Connect on–street public transport display
Shelter / flag set out
Version 03

City ID April 2005

2. Closed to kerb_Shelter and freestanding flag

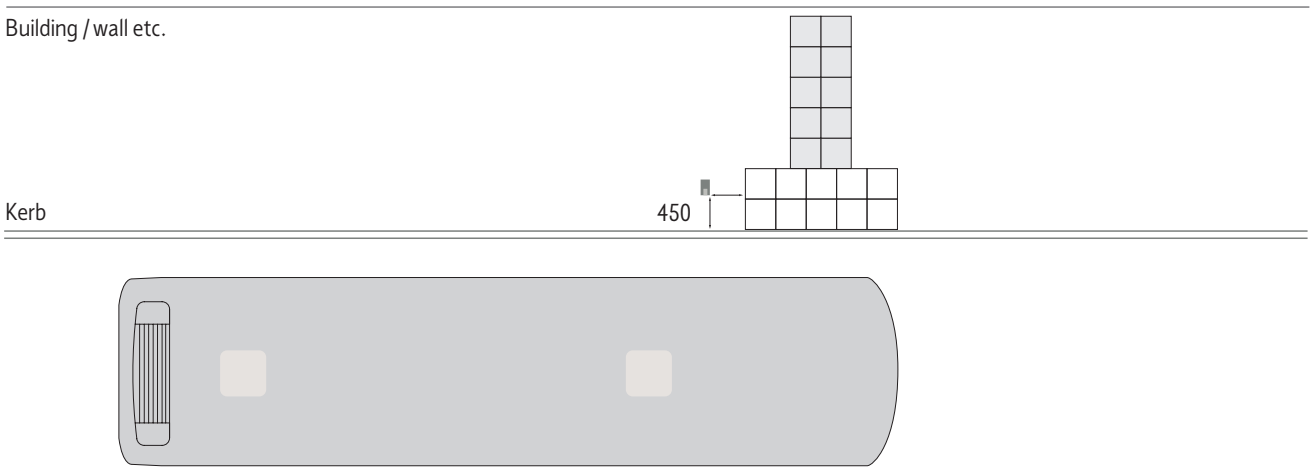
_Closed to kerb shelter set out – space between the rear shelter panel glazing and the kerb edge has been increased from 450mm to 550mm to allow for 65mm roof glazing overhang.
